Access Compliance Report

Public Rights-of-Way

Intersection ID: 29178	Main Street: HARRIS_CENTER_DR	Cross Street: STATESVILLE_RD	Location: W
ADA ID: C34C3D75926B	Ramp Type: Perp	Initial Pass/Fail: Fail	Overall Compliance: No
Severity Score: 25			
Codes/Mitigation Info/Possible Solution		Field Measurements/Component Compliance

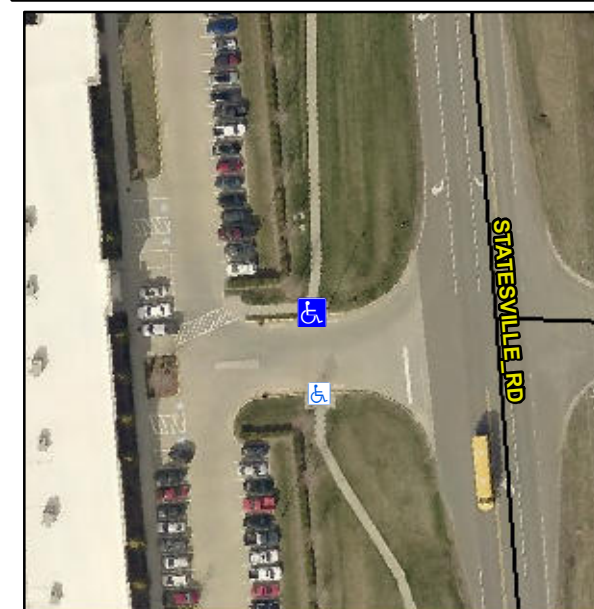
R304.2.2, R304.5.3

Compliance	Description	Data	Compliance	Description	Data
N/A	Ramp Length (in)	96.0	No	Ramp Slope (%)	9.4
Yes	Ramp Width (in)	48.0	No	Ramp XSlope (%)	5.6
N/A	Flare Type LT	N/A	N/A	Flare Type RT	N/A
N/A	Flare Slope LT (%)	N/A	N/A	Flare Slope RT (%)	N/A
N/A	Flare Traversable LT?	N/A	N/A	Flare Traversable RT?	N/A
N/A	Landing Length (in)	N/A	N/A	DWS Provided?	N/A
N/A	Landing Width (in)	N/A	N/A	DWS Contrast?	N/A
N/A	Landing Slope (%)	N/A	N/A	DWS Length (in)	N/A
N/A	Landing X Slope (%)	N/A	N/A	DWS Full Width?	N/A
N/A	Landing Curb? (Y/N)	N/A	N/A	DWS Offset (in)	N/A
N/A	Shared Landing?	N/A			
N/A	Gutter Ponding?	N/A	N/A	Gutter Slope (%)	N/A
N/A	Gutter Lip Ht (in)	0.5	N/A	Gutter X Slope (%)	N/A
N/A	Painted X Walk1?	No	N/A	Painted X Walk2?	N/A
	X Walk 1 Direction	To S		X Walk 2 Direction	N/A
N/A	X Walk 1 Width (in)	N/A	N/A	X Walk 2 Width (in)	N/A
	X Walk 1 Slope (%)	2.4		X Walk 2 Slope (%)	N/A
	X Walk 1 X Slope (%)	5.9		X Walk 2 X Slope (%)	N/A

Remove & Replace Entire Ramp.
